South Dakota Science and Technology Authority Questions

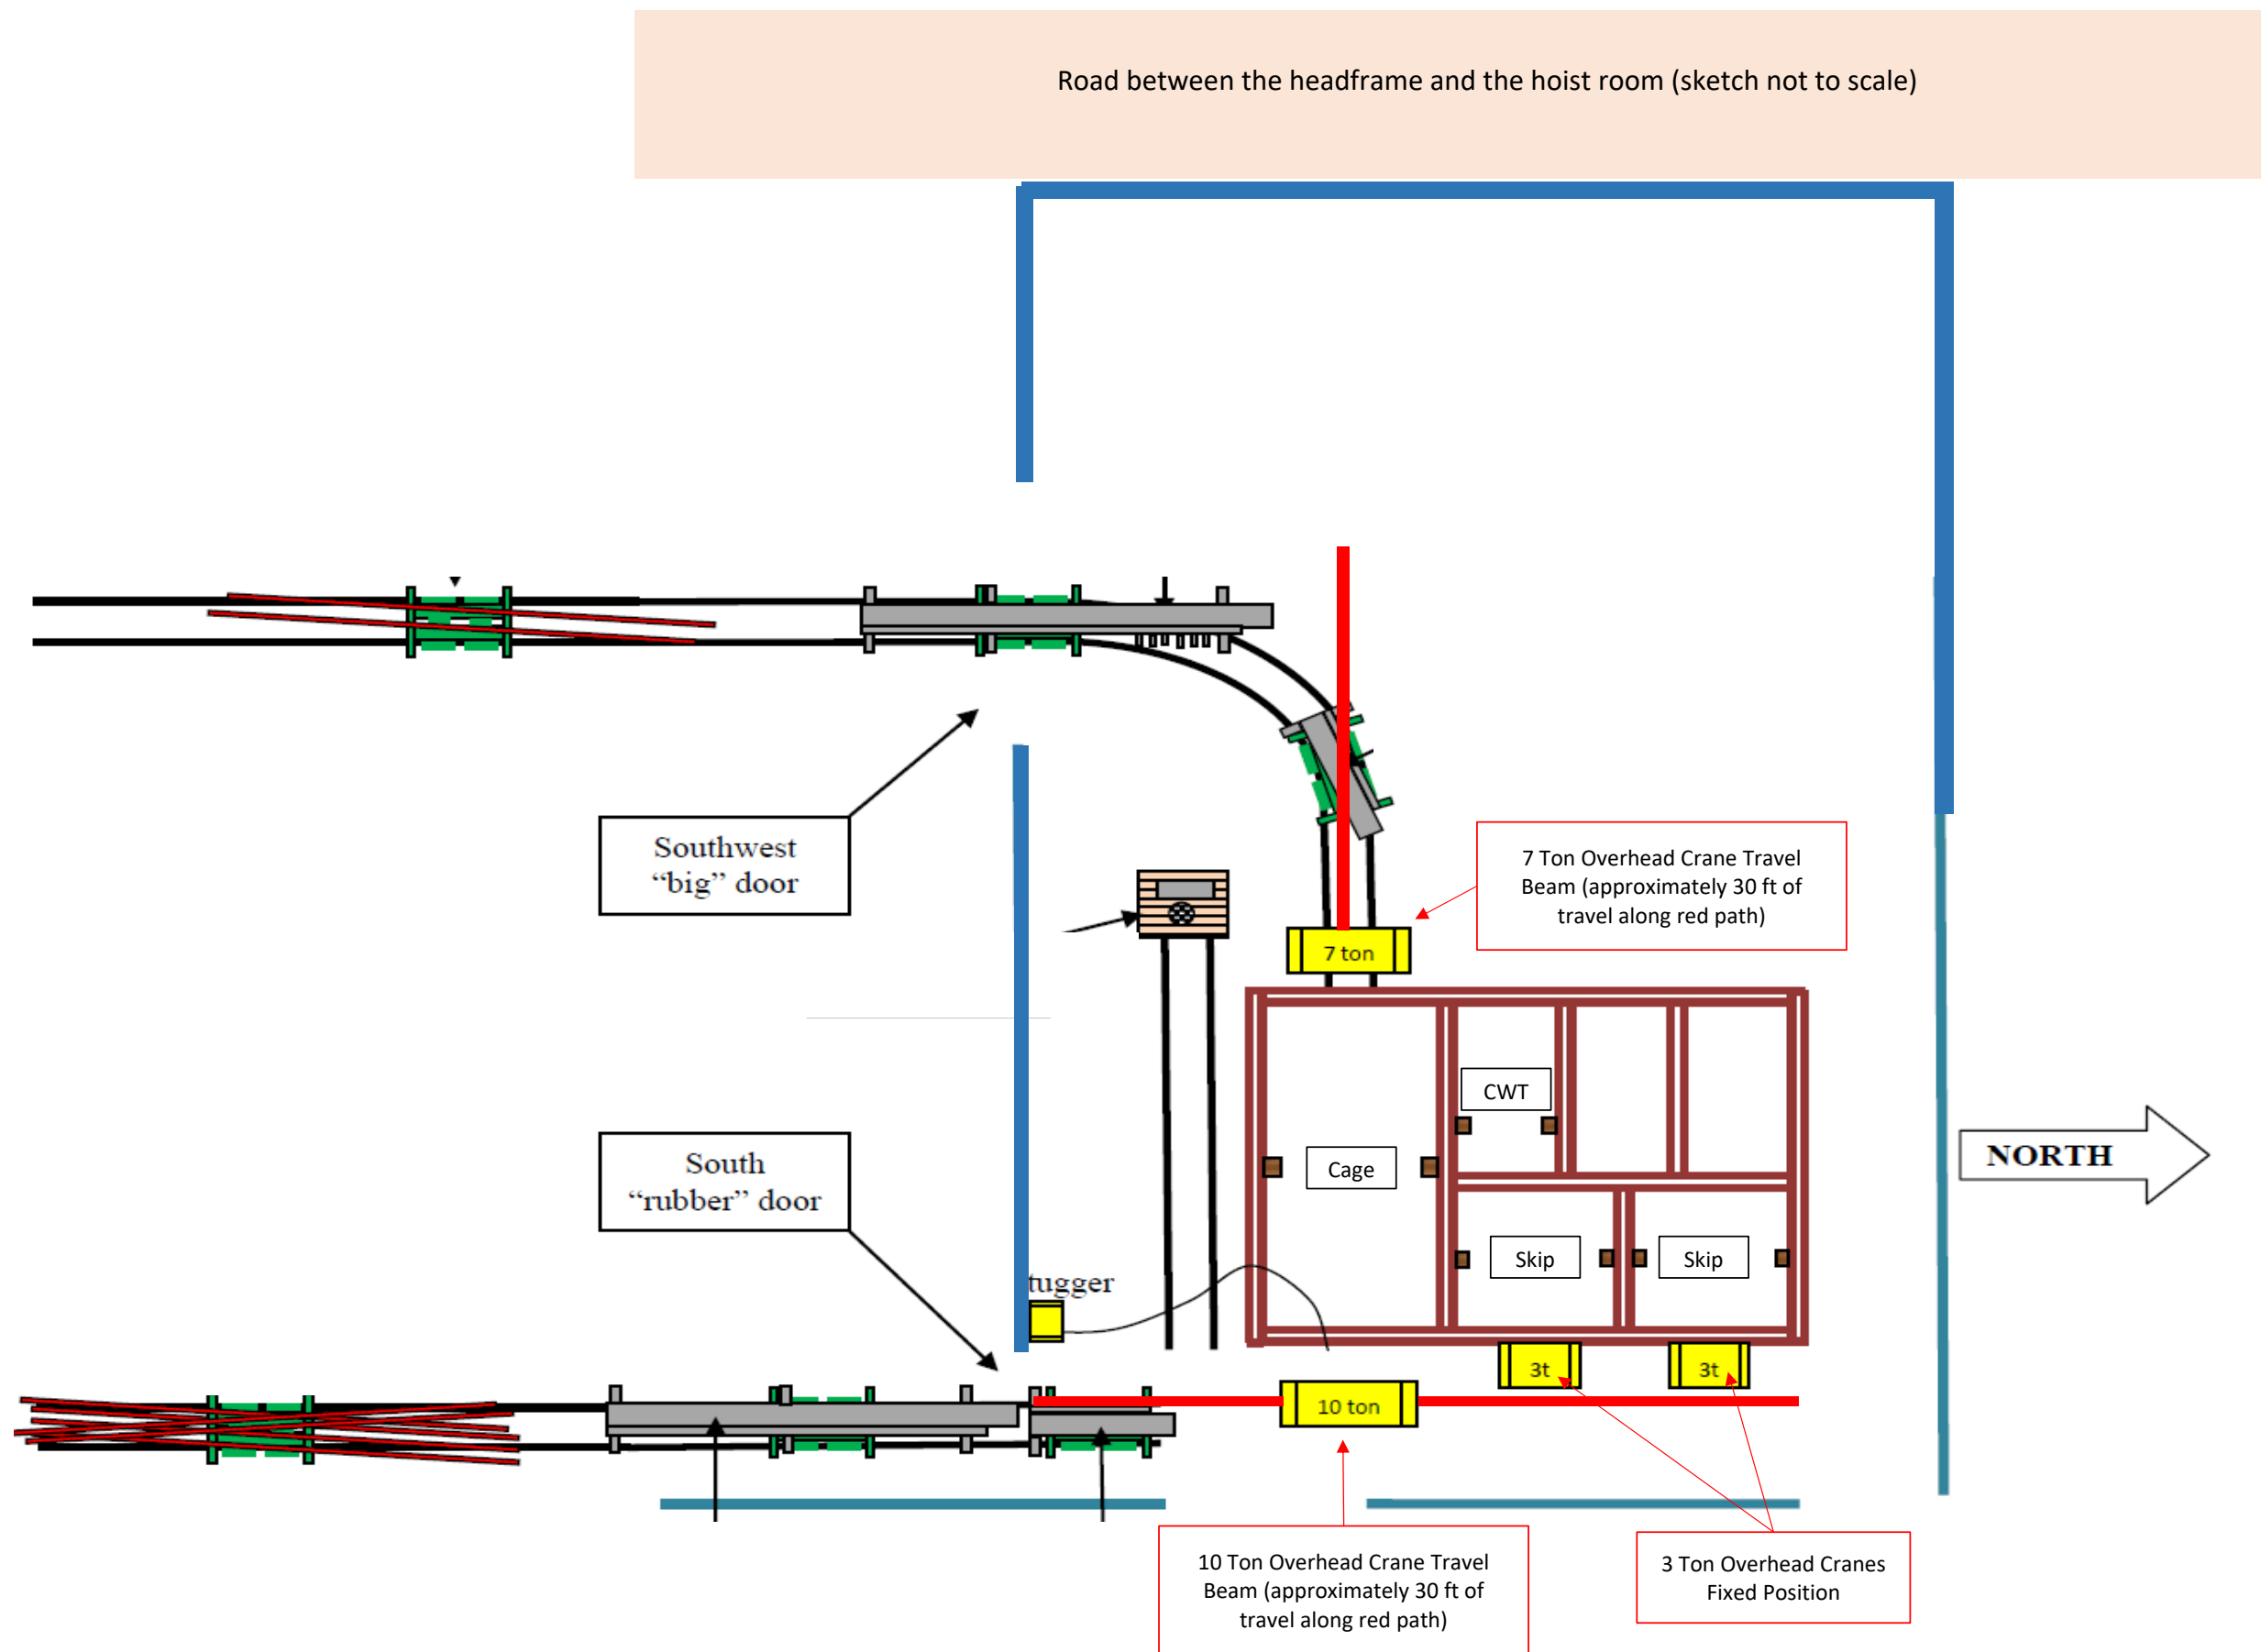
- 5) Please provide details of concrete pad in headframe and outside of headframe so contractor can assess anchorage requirement.
[Inside the headframe there is an 8 inch concrete floor \(see attached drawing\). However, outside the headframe there is no concrete. There is an old concrete pad used for previous rope changes during Homestake mining but there is no information about the pad itself \(see attached photos\)](#)
